**ADDENDUM
NO. 1**

October 28, 2022

**LIBERTY ELEMENTARY SCHOOL RENOVATIONS
Chesterton, IN 46304**

This Addendum consists of Pages ADD 1-1 and attached Addendum No. 1 from Gibraltar Design dated October 26, 2022 and consisting of 4 pages, Hardware Set 17, and 23 Drawings.

© GIBRALTAR DESIGN SHEET
B EL102

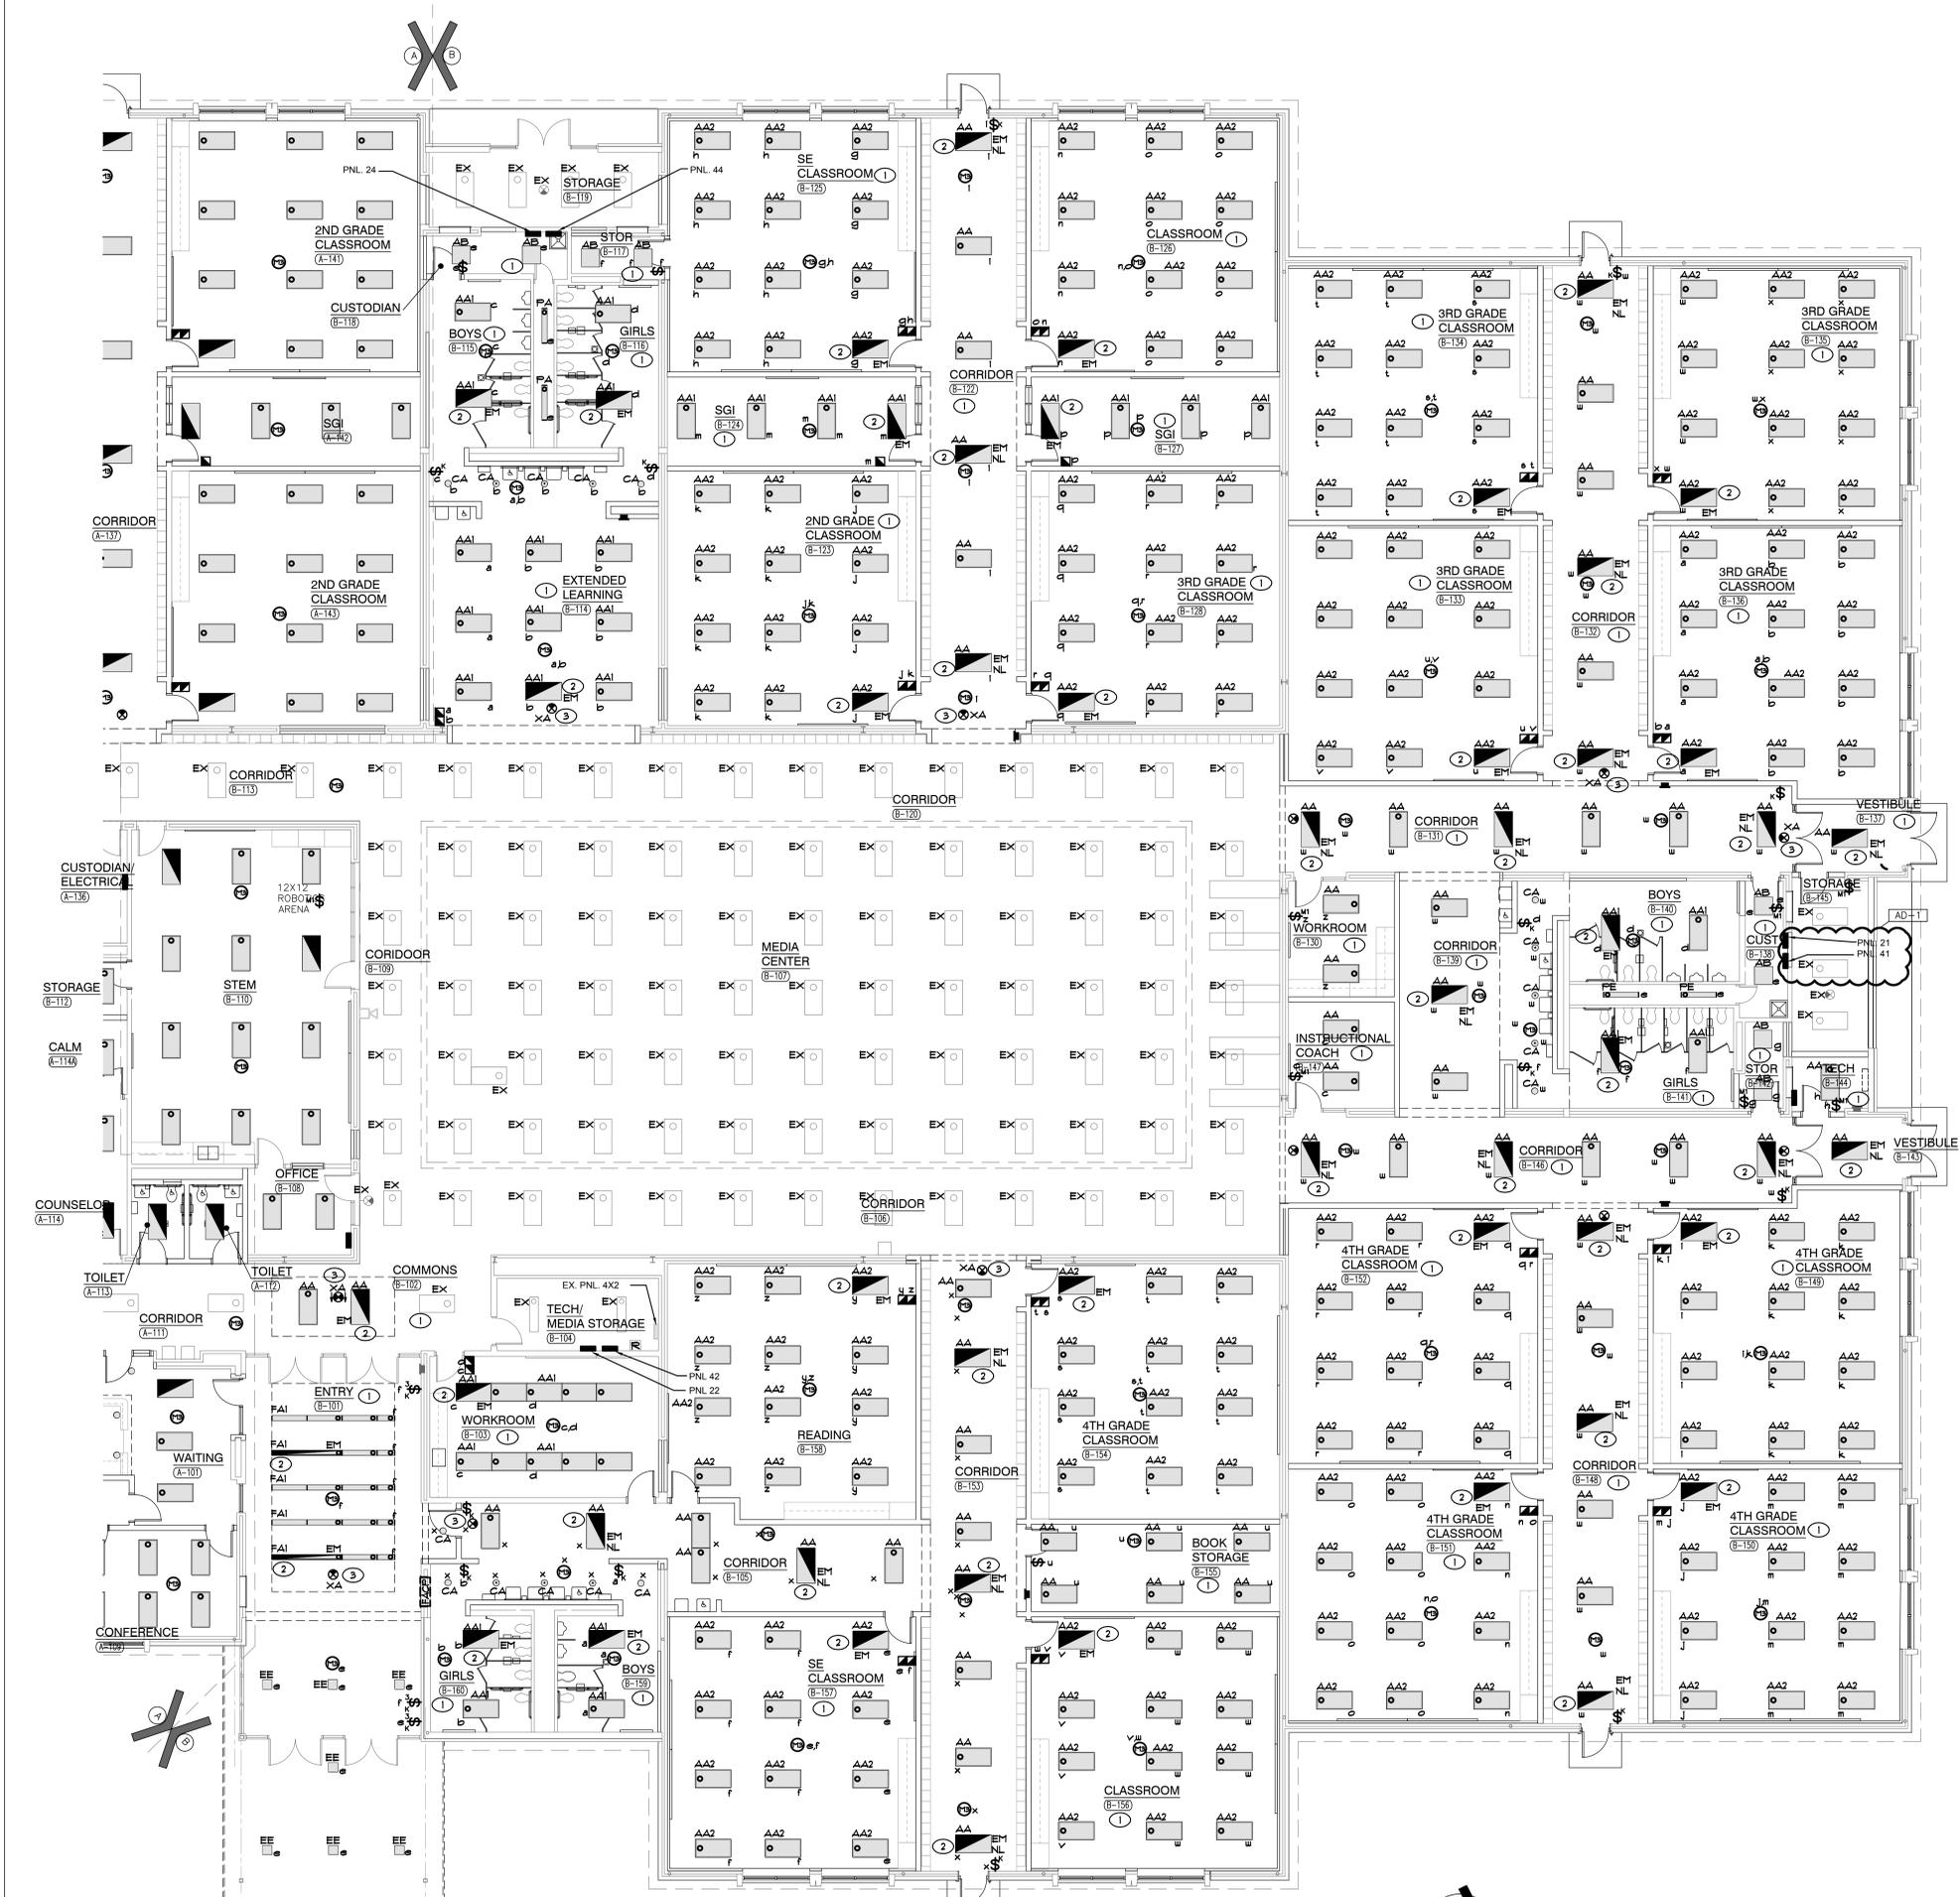
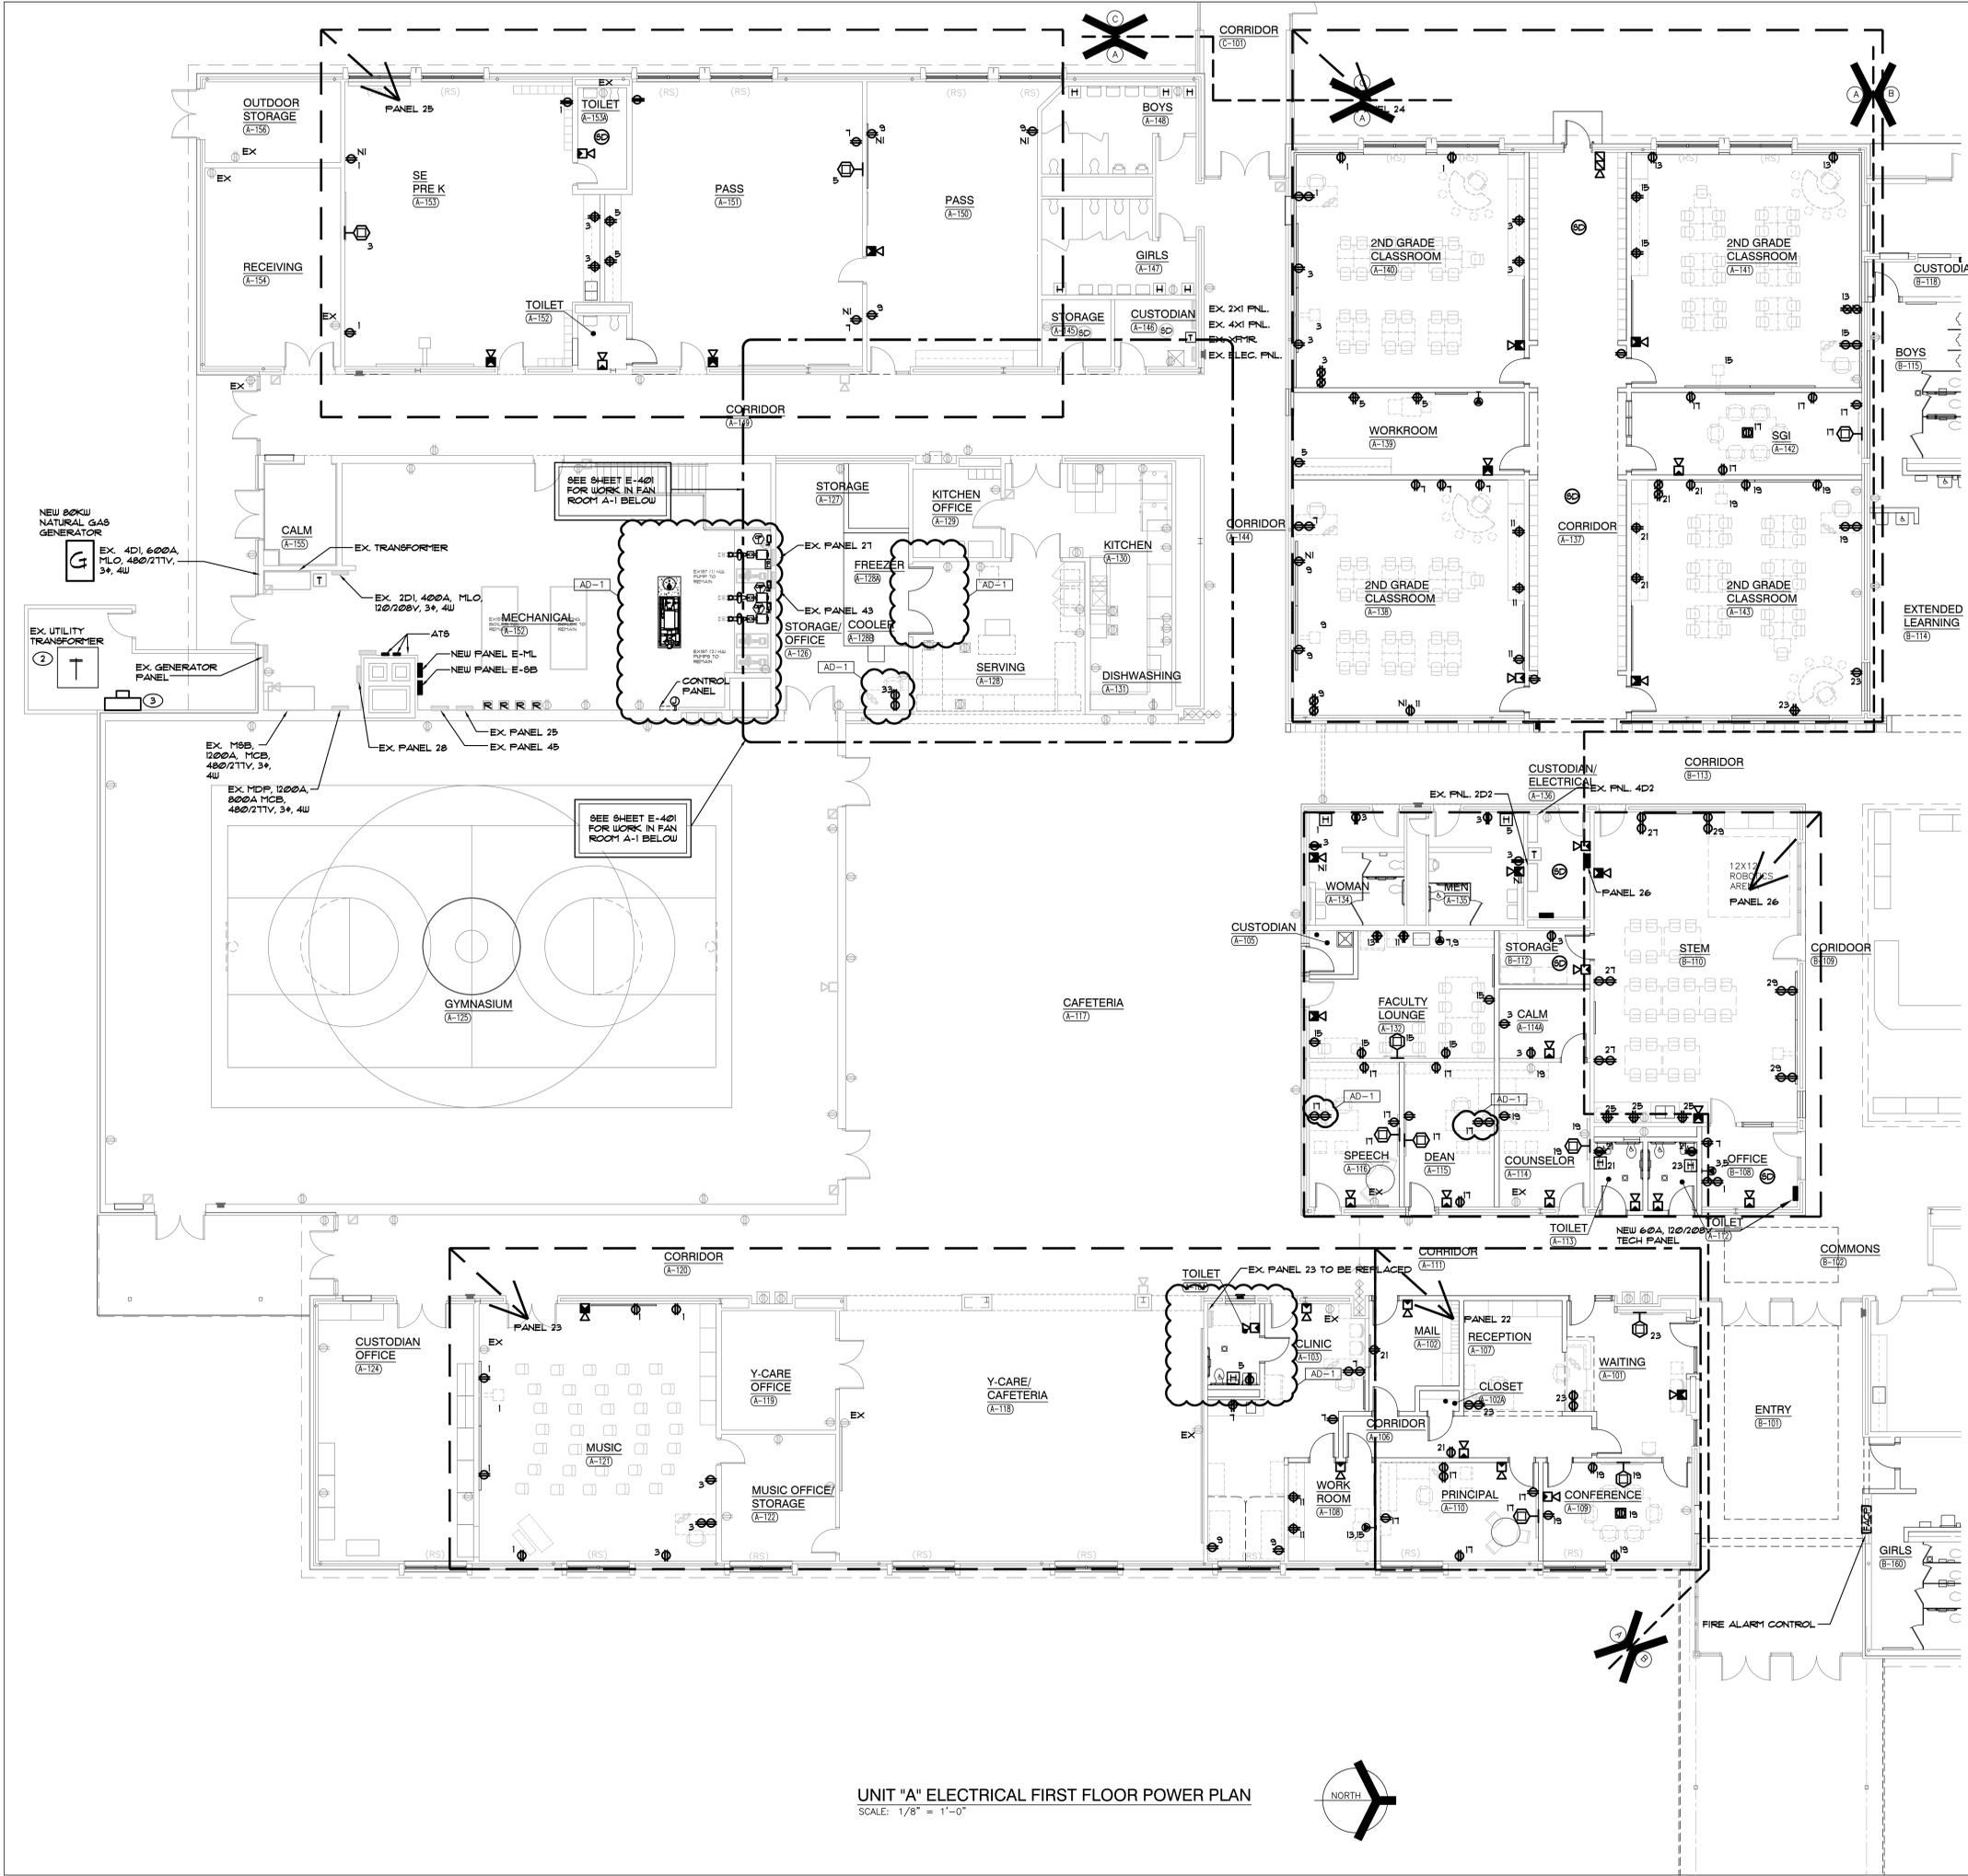
17. Sheet EL101 and EL102

- A. Refer to revised full size drawings, included in this Addendum, for the following revisions:
 - 1. Revised new work devices and requirements.

GIBRALTAR DESIGN SHEET
A EP101

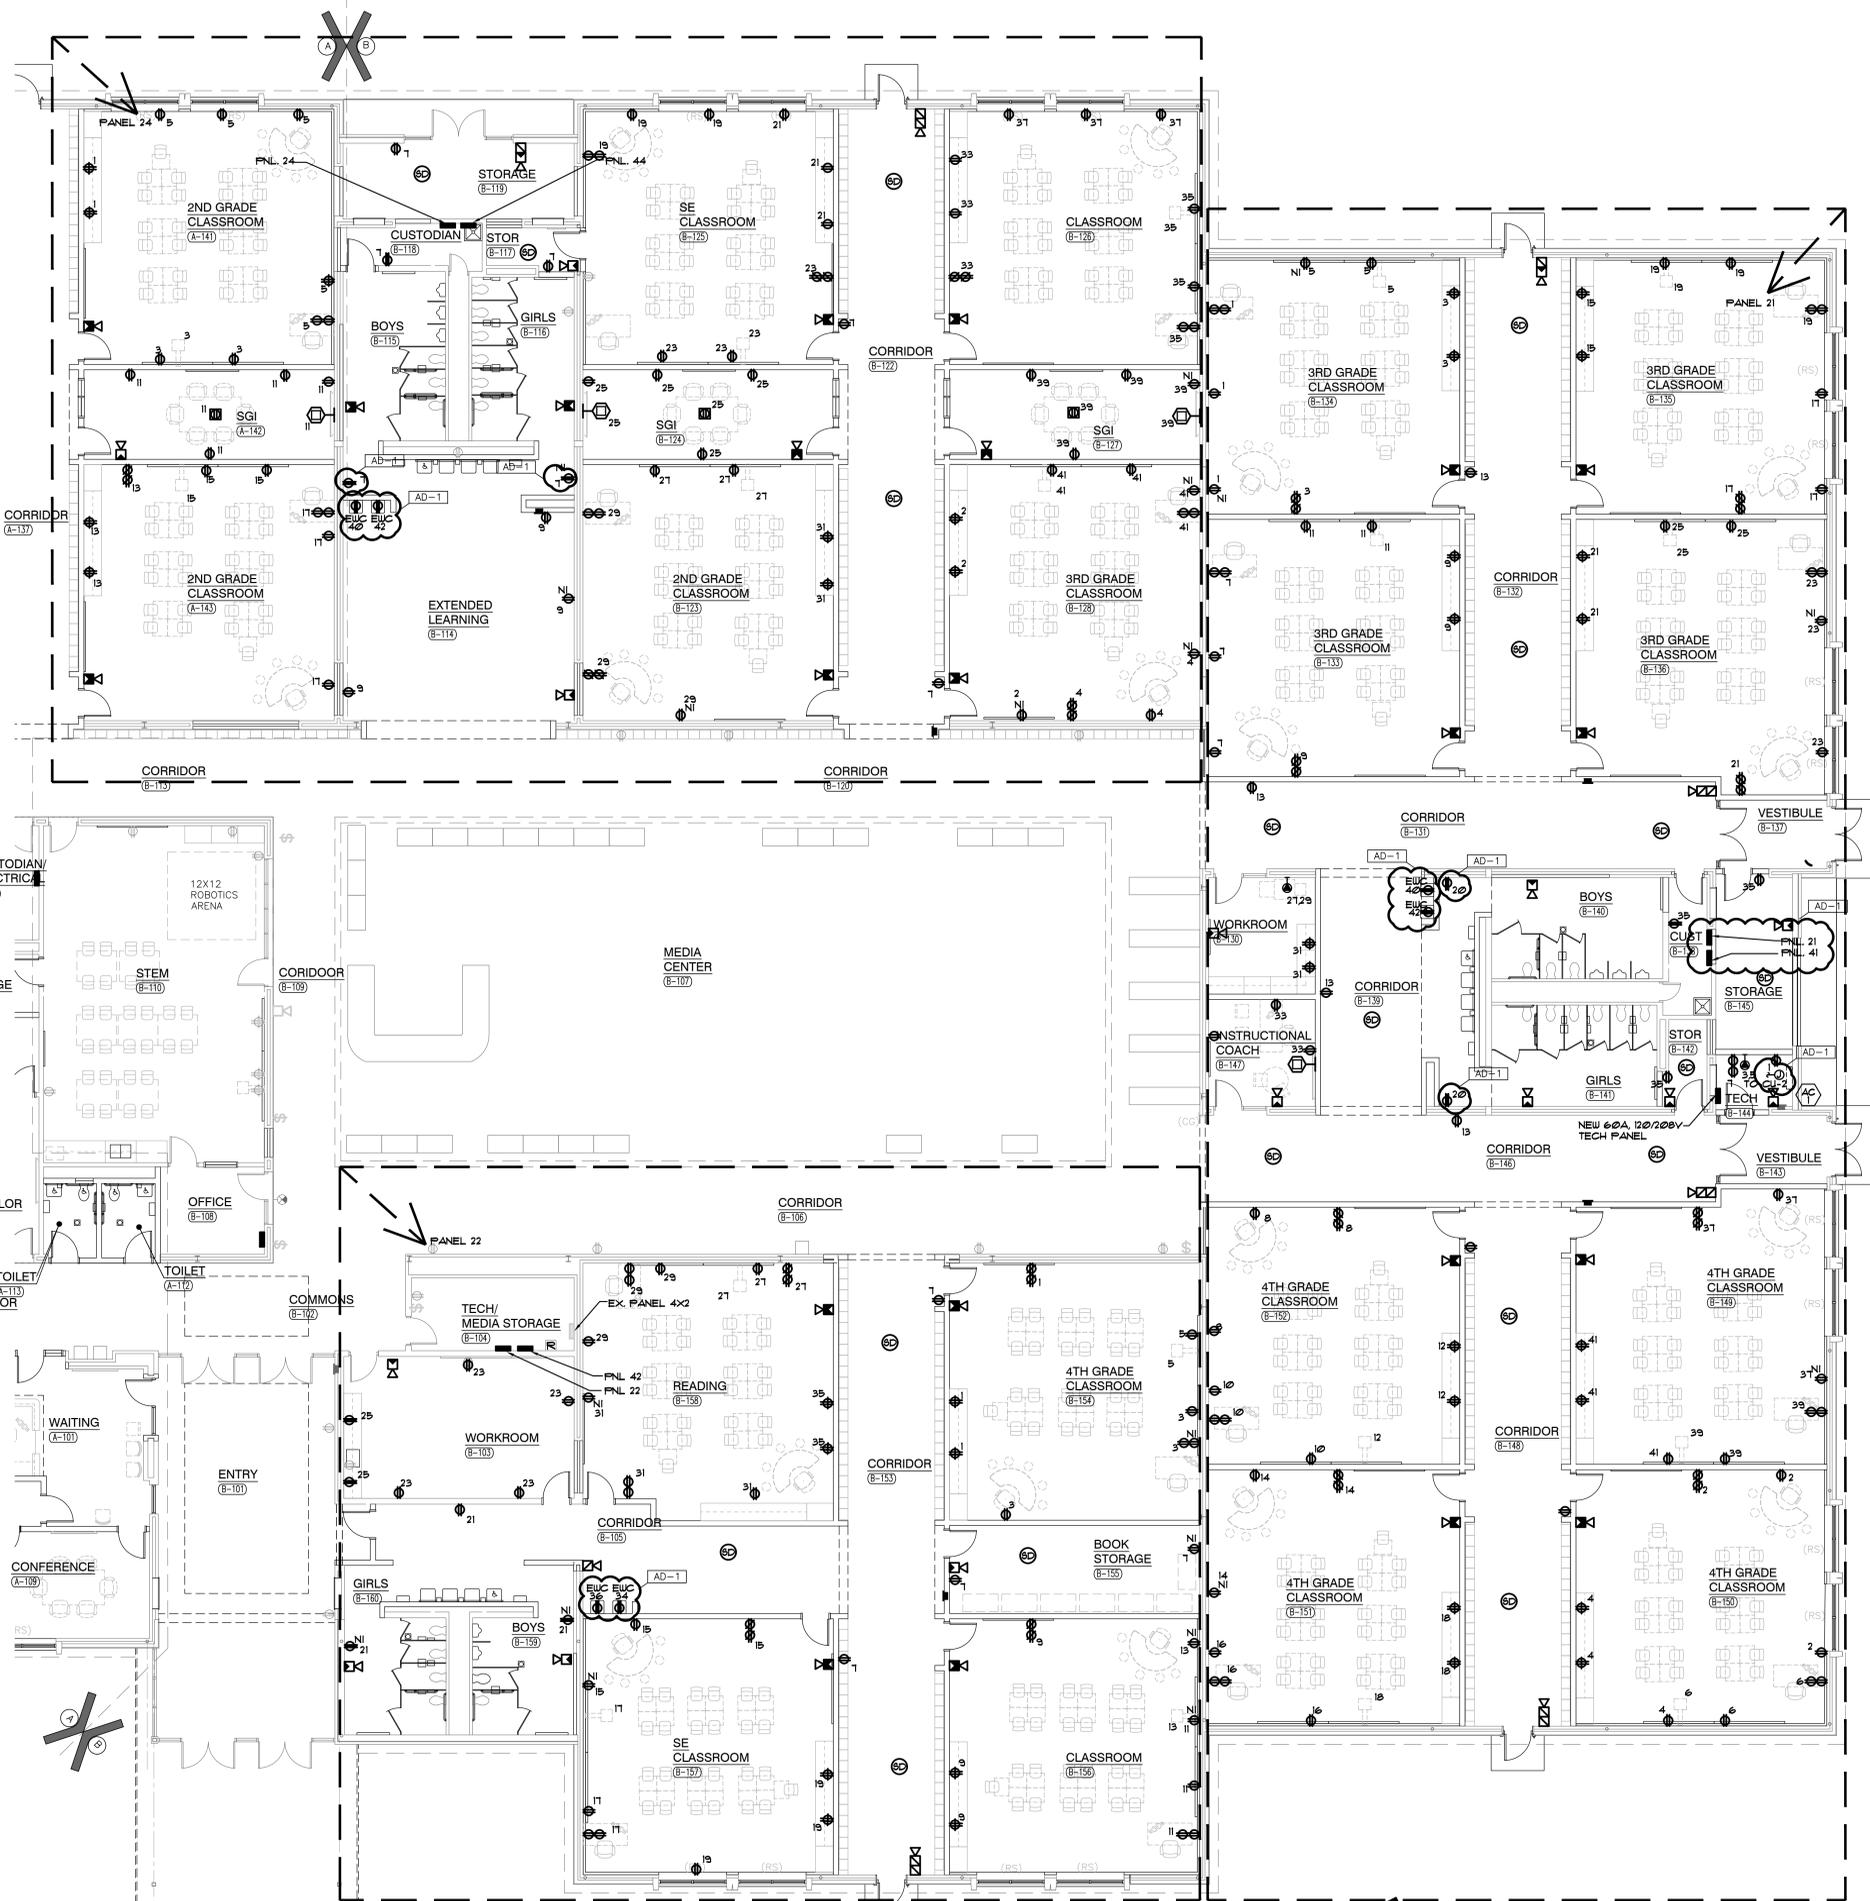
18. Sheet EP101 and EP102

- A. Refer to revised full size drawings, included in this Addendum, for the following revisions:
 - 1. Revised new work devices and requirements.
